Rockwell service letter No. SL-AG-79

Service Letter No. SL-AG-79
30 January, 1976

CARBURETOR HEAT MODIFICATION

MODELS AFFECTED: S-2R, S/N 5000 thru 5082.

Figure 1.

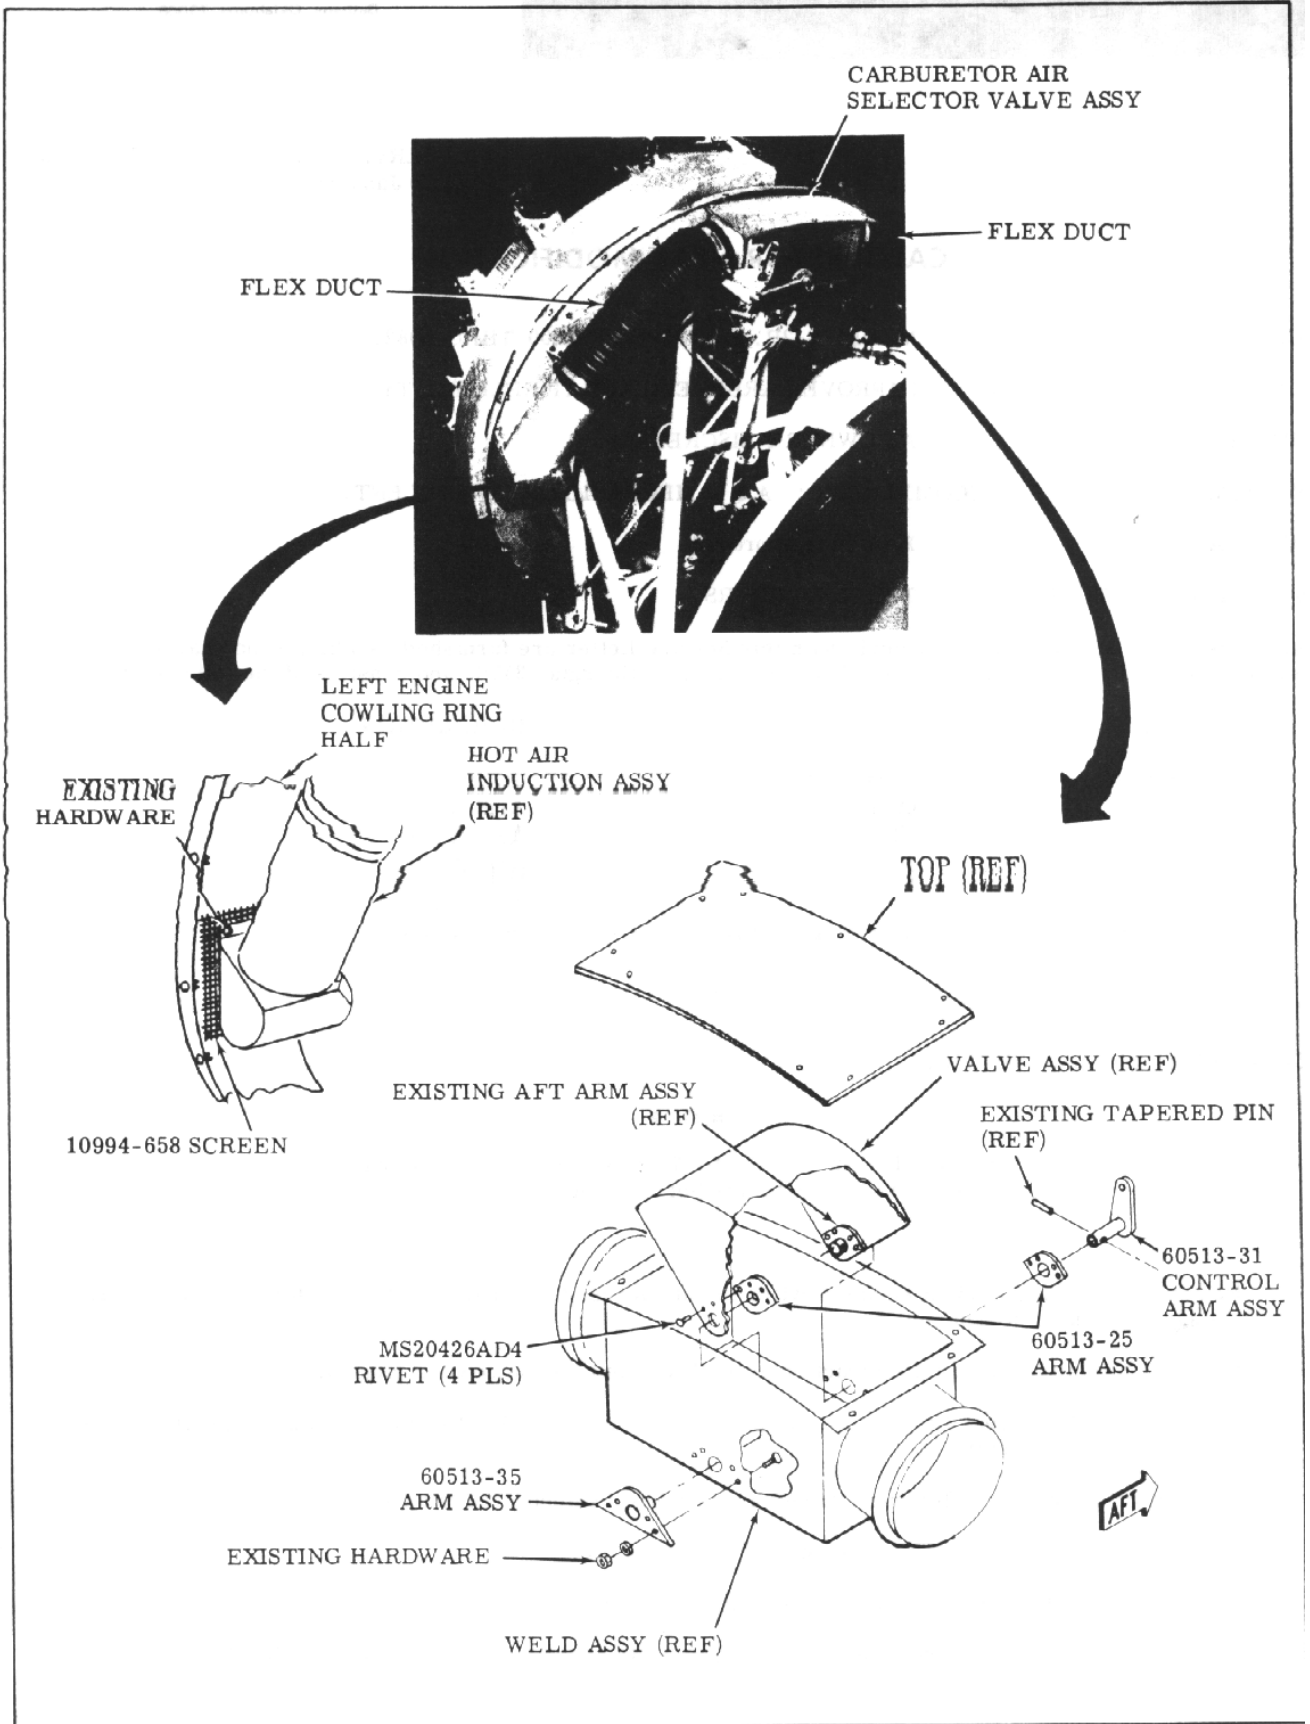
- 3 Install 10994-658 screen between hot air induction assembly and left engine cowling ring half using existing hardware (see Figure 1).
- 4 Disconnect controls and flex ducts from carburetor air selector valve assembly.

- 8 Remove tapered pin that attaches control arm assembly to valve assembly and remove valve assembly.
9. Remove forward arm assembly from valve assembly and install 60513-25 arm assembly using MS20426AD4 rivet (4 places)(see figure 1).

10. Remove and discard aft arm assembly from weld assembly.
11. Install 60513-25 arm assembly on aft hole in weld assembly using MS20426AD4 (4 places)(see Figure 1).

12. Install valve assembly in weld assembly and install 60513-31 control arm assembly on valve assembly using existing tapered pin (see Figure 1).
13. Install 60513-35 arm assembly on forward hole in weld assembly using existing hardware (see Figure 1).
